MEMORANDUM FOR Records of the NIOSH Excavation Project

Subject: Workshop in Boston, Massachusetts, July 14, 1981

STATEMENT OF POSITION AND RECOMMENDATIONS
ON
REVISION TO SUBPART P
OF THE
SAFETY AND HEALTH REGULATIONS FOR CONSTRUCTION
PRESENTED BY
THE MAJOR MANUFACTURERS OF TRENCH BOXES
AND TRENCH SHIELDS OF THE UNITED STATES

Workshop to Review and Comment on the National Bureau of Standards Recommended Technical Provisions for Construction Practice in Shoring and Sloping of Trenches and Excavations.

Figure 4. Components of the Shoring System

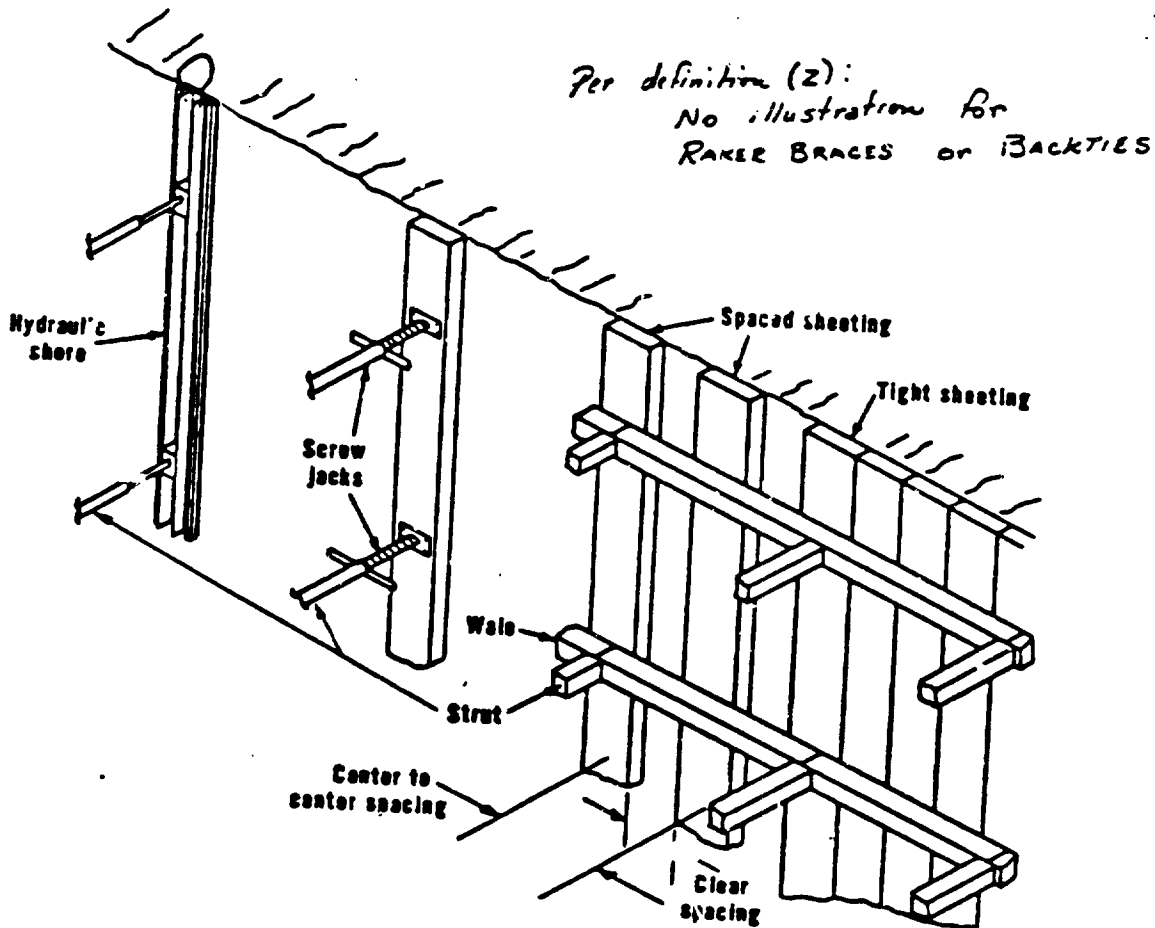
- ✓ (w) Spaced Sheeting is sheeting in which the members bearing against the excavation wall are spaced (see Figure 6). Figure 4?
- ✓ (x) Spalling is the continuous flaking and falling of soil or rock from an unsupported trench wall.

- ✓ (y) Standard Practice is the trenching and shoring practice in Section 1926.652 (b).
- ✓ (z) Struts are the primary support members of a shoring system including but not limited to cross braces, raker braces, jacks and backties (see Figure 6) Figure 4?

Raker braces or backties are not illustrated

Should read ... See Figure 4 (Correction)
